UNITED STATES PATENT AND TRADEMARK OFFICE

Application No.	Applicant(s)				
	10/763,556	HINSBERGER ET AL.				
Office Action Summary	Examiner	Art Unit				
	Michael P. Ferguson	3679				
The MAILING DATE of this communication appears on the cover sheet with the correspondence address Period for Reply						
A SHORTENED STATUTORY PERIOD FOR REPLY IS SET TO EXPIRE 3 MONTH(S) FROM THE MAILING DATE OF THIS COMMUNICATION. - Extensions of time may be available under the provisions of 37 CFR 1.136(a). In no event, however, may a reply be timely filed after SIX (6) MONTHS from the mailing date of this communication. - If the period for reply specified above is less than thirty (30) days, a reply within the statutory minimum of thirty (30) days will be considered timely. - If NO period for reply is specified above, the maximum statutory period will apply and will expire SIX (6) MONTHS from the mailing date of this communication. - Failure to reply within the set or extended period for reply will, by statute, cause the application to become ABANDONED (35 U.S.C. § 133). Any reply received by the Office later than three months after the mailing date of this communication, even if timely filed, may

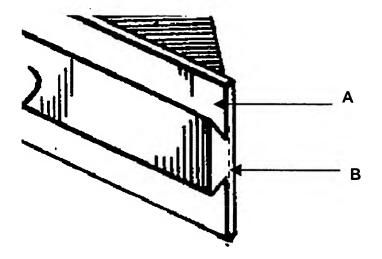
As to claim 1, Lawrence et al. disclose a securing device capable of use with rear walls set in grooves of cabinet furniture, the securing device including a first support element A (Figure 10 reprinted below with annotations) placed in an angle area between a rear wall 175 and grooved sidewall 160 and a second support element A placed between the rear wall and a grooved board 161, whereby the first and second support elements each have contact sides at a right angle to one another and diagonal to the contact sides a through hole 55,56 capable of receiving a screw or set pin 50,51, wherein the first and second support elements are integrated in one piece into two legs A of a corner angle piece, and wherein the legs are at a right angle to one another, and whereby one of the first and second support elements is formed at each of the legs (Figures 6, 7, 10-12 and 14).

As to claim 2, Lawrence et al. disclose a securing device wherein the legs **A** of the corner angle piece including the first and second support elements **A** have support bars at a right angle to one another and including strike sides, wherein the strike sides comprise the contact sides of the support elements (Figure 10).

As to claim 10, Lawrence et al. disclose a securing device including bars 31,32 protruding transversely from the legs **A**, wherein the bars have longitudinal sides **B**, and wherein one the bars is planar with a strike side of the legs of the corner angle piece located the same plane (Figure 10).

As to claim 11, Lawrence et al. disclose a securing device wherein the bars 31,32 are spring-like and taper off in a wedge shape toward their longitudinal sides B (Figure 10).
